PUBLIC INTEREST REVIEW FOR GROUND WATER APPLICATIONS

SUBJECT: Application G- 16851 Supersedes review of none

A. GENERAL INFORMATION: Applicant's Name: Thomas Whipple & Jacqueline Yorton County: Harney

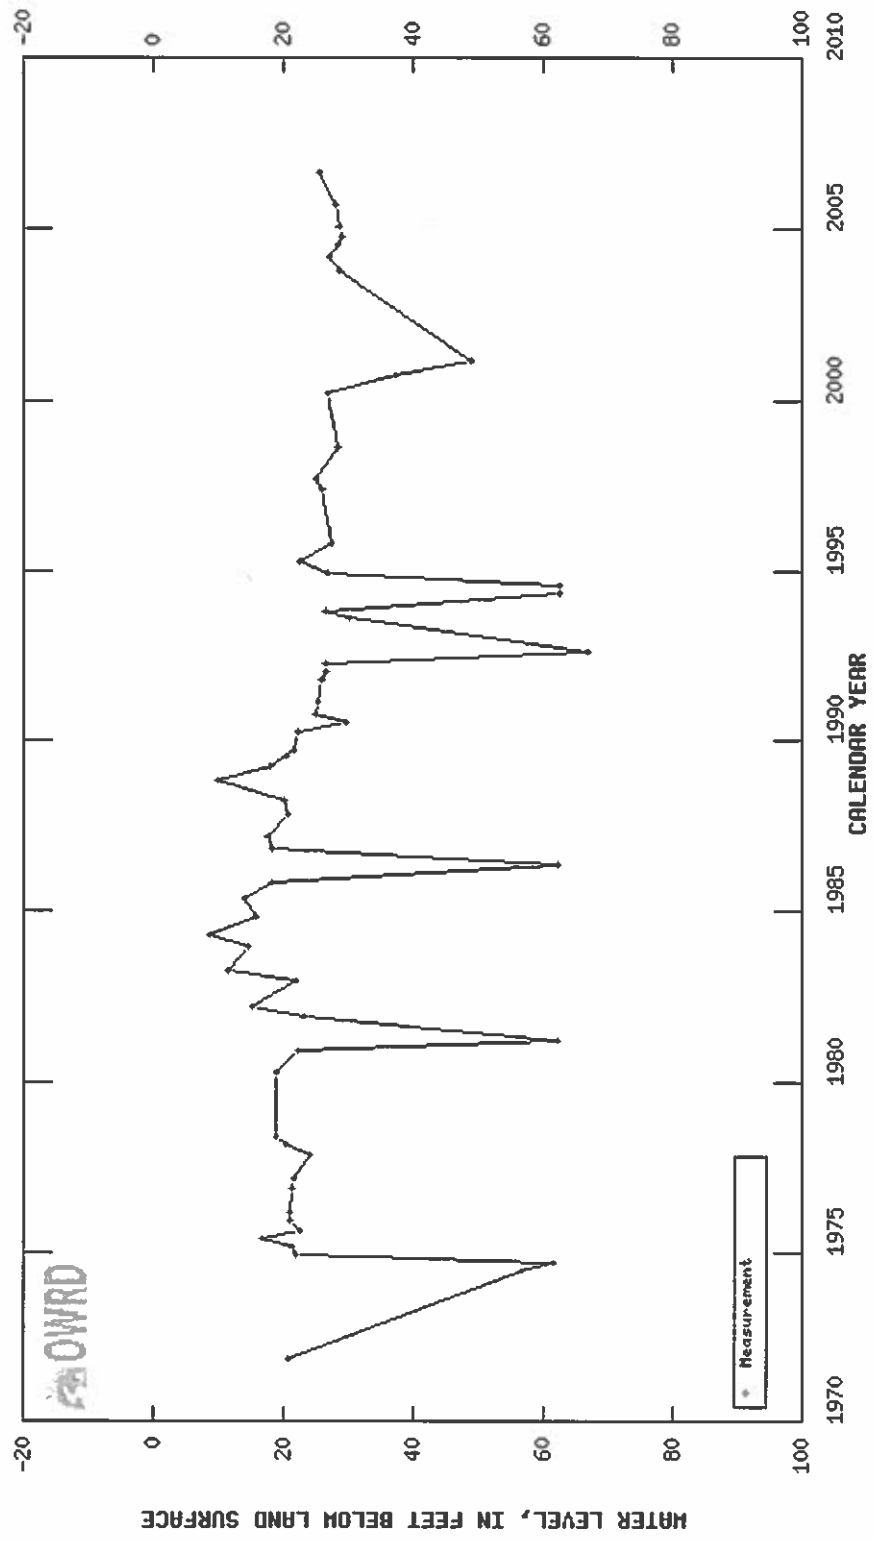
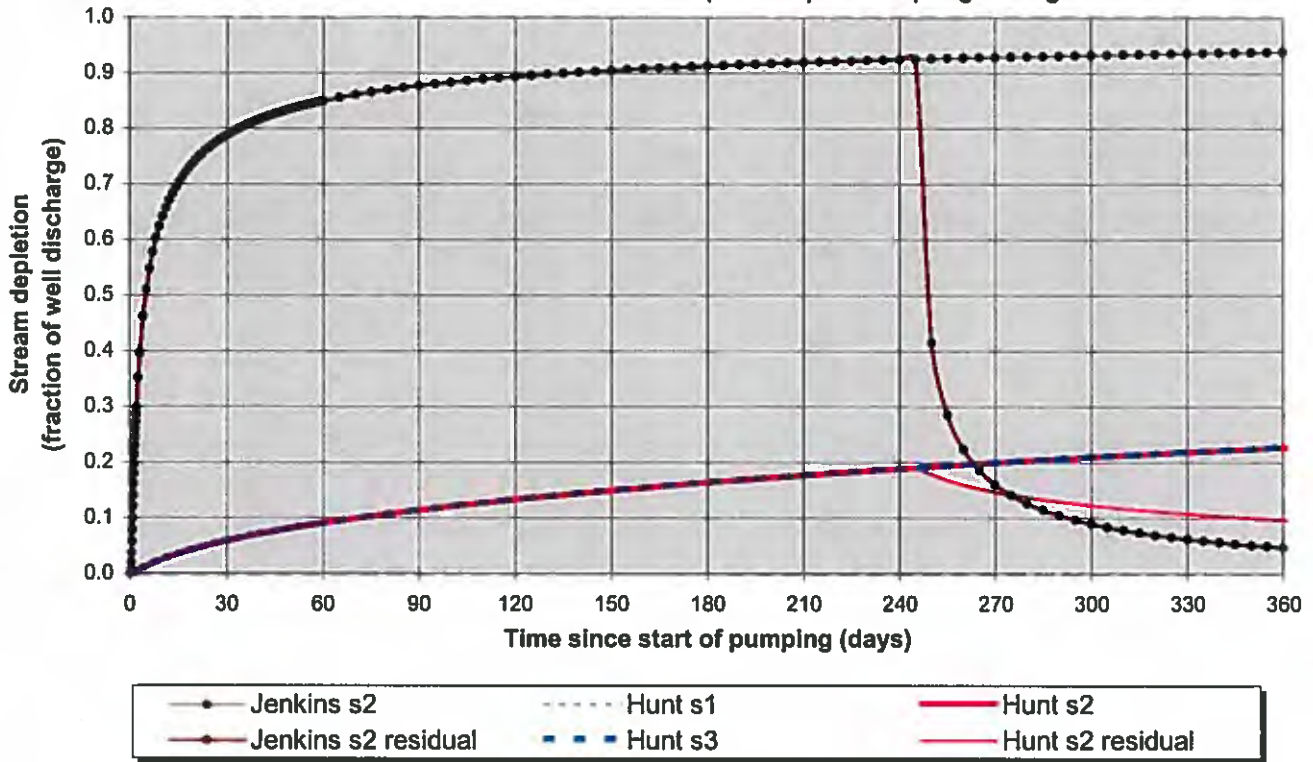
The closest well with ground water level trend data is well HARN 741 in T23S/R34E-sec 31 (about 1.9 miles to the northeast) which is completed in sediments. The ground water level data for HARN 741 is from 1974 to 2006. The ground water level trend at the site shows seasonal and climatic influences. A possible net decline of less than 5 feet may have occurred at the site. Interestingly, no recovery of the annual trend is apparent from 1996 to 1999, a generally wetter than average period in Oregon. Seasonal ground water level fluctuations range from 10 to 40 feet. This could adversely impact the use of shallow wells, but likely not adversely impact the use of deeper wells.

The closest well with ground water level trend data is well HARN 741 in T23S/R34E-sec 31 (about 1.9 miles to the northeast) which is completed in sediments. The ground water level data for HARN 741 is from 1974 to 2006. The ground water level trend at the site shows seasonal and climatic influences. A possible net decline of less than 5 feet may have occurred at the site. Interestingly, no recovery of the annual trend is apparent from 1996 to 1999, a generally wetter than average period in Oregon. Seasonal ground water level fluctuations range from 10 to 40 feet. This could adversely impact the use of shallow wells, but likely not adversely impact the use of deeper wells.
